1		FILED IN OPEN COURT
2		WHATCOM GOUNTY CLERK
3		Ву
4		Deputy
5		
6		
7		ASHINGTON Y SUPERIOR COURT
8	STATE OF WASHINGTON,)
9	DEPARTMENT OF ECOLOGY,	NO. 07-2-02257-7
10	Plaintiff,	FIRST AMENDMENT TO CONSENT
11	v.	DECREE RE: WHATCOM WATERWAY SITE
12	PORT OF BELLINGHAM, a Washington municipal corporation; WASHINGTON	
13	STATE DEPARTMENT OF NATURAL RESOURCES; MERIDIAN-PACIFIC	
14	HWY, L.L.C., a Washington limited liability company; and the CITY OF	
15	BELLINGHAM, a Washington municipal corporation,	
16	Defendants.	
17	Defendants.	
18	Pursuant to Section XV of the Cons	sent Decree Re: Whatcom Waterway Site (the
19	"Consent Decree"), entered by this Court	on September 24, 2007, Plaintiff, State of
20	Washington, Department of Ecology (Eco	ology), and Defendants, Port of Bellingham,
21	Washington State Department of Natural Re	esources (DNR), Meridian-Pacific Hwy, L.L.C.,
22	and the City of Bellingham, hereby stipulate to	amend the Consent Decree as follows:

First Amendment to Consent Decree Re: Whatcom Waterway Site, Bellingham, WA

First Amendment to EXHIBIT B Cleanup Action Plan

Figure 7-2. Implementation Schedule - First Amendment to Cleanup Action Plan [1][4]

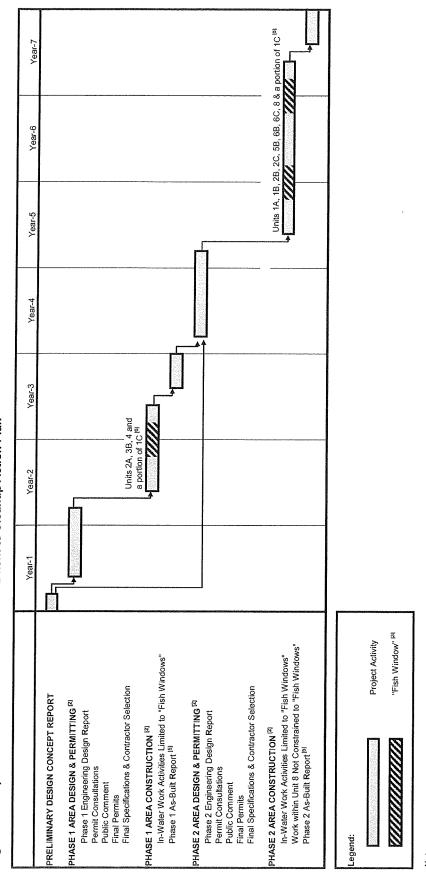
[And, Figure 7-2 is replaced with the following:]

The project schedule was also adjusted to reflect the implementation of the work as two construction actions or phases, each under its respective permits. This provides for expedited cleanup of the inner waterway, the Log Pond, and portions of the Site that are independent of Unit 8. This work also accommodates early redevelopment actions. The adjusted project schedule is attached to the Decree as Exhibit C, and is shown in Figure 7-2.

The schedule for design and implementation of the Whatcom Waterway cleanup is attached to the Decree as Exhibit C and is illustrated in Figure 7-2. The considerations for the schedule selected are described below;

- 1 This figure illustrates the anticipated schedule for design, permitting and construction activities under the First Amendment to the Cleanup Action Plan. Actual duration is subject to change based on time required

2 The phasing and construction sequence is subject to change based on permit requirements and final design. Each project phase is separate from the other and can be implemented independently. 3 Construction activities within Bellingham Bay surface waters are expected to be limited to appropriate seasonal "fish windows" specified in project permits, to avoid impacts to juvenile salmonids. 4 Long-term monitoring activities are not shown. As described in Section 6, these are expected to include monitoring events 1, 3, 5, 10, 20 and 30 years after completion of construction. 5 Restrictive Covenants to be filed prior to Ecology approval of the as-built report. 6 Units 3A, 5A, 5C, 6A, 7, and 9 are designated for monitored natural recovery. Monitoring will be performed consistent with the Compliance Monitoring and
 - Contingency Response Plan, to be prepared during design and permitting.
